Product Change Notification

Overview: Please be advised that the following is notice of change to the Fire Research recessed lighting fixture model OPA230 with HID (High Intensity Discharge) bulbs.

OPA230-H70, OPA230-H15, OPA230-E70, OPA230-E15

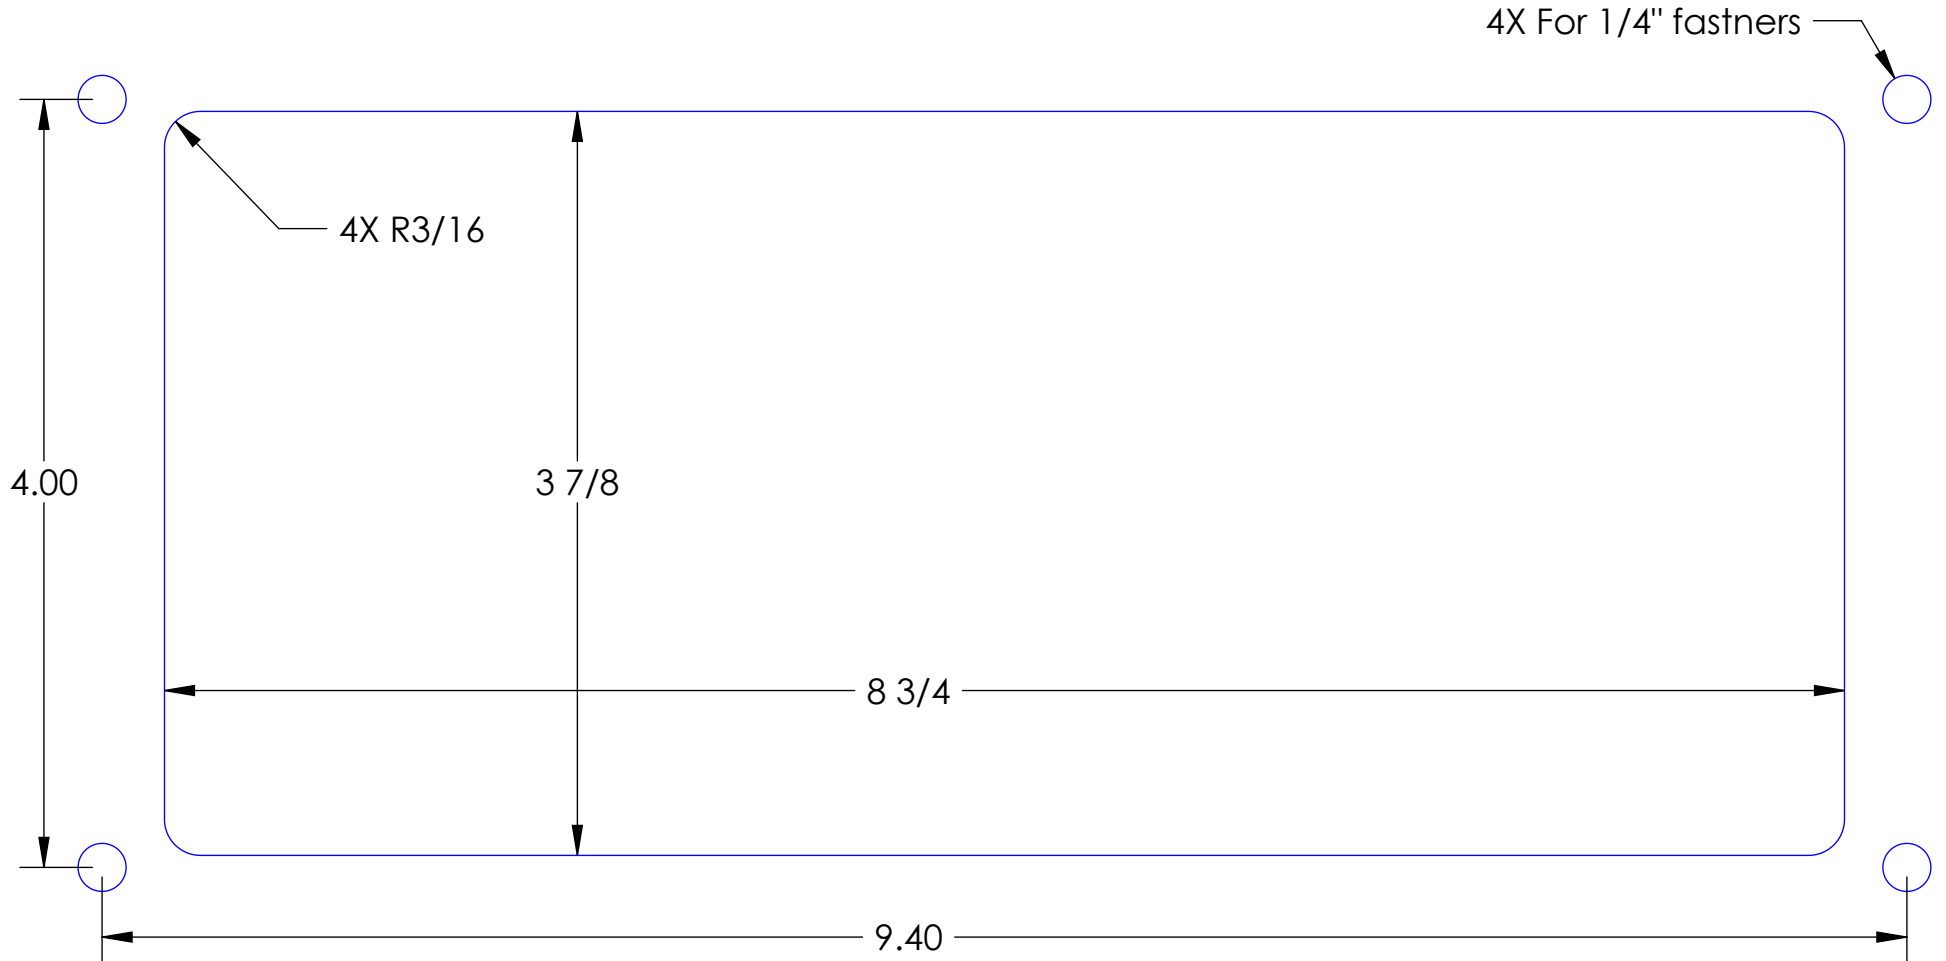
Change Description: The required panel cutout dimension has changed. The new cutout dimension is 5/8" higher. (It is 3 7/8 by 8 3/4.)

Reason For Change: Improvements in the casting the holds the lamphhead.

The mounting screw hole pattern is the same as the old casting. The panel cutout for the old casting can be enlarged at the top and bottom to fit the new casting.

Replacement Product: All models will be shipped with the new casting.
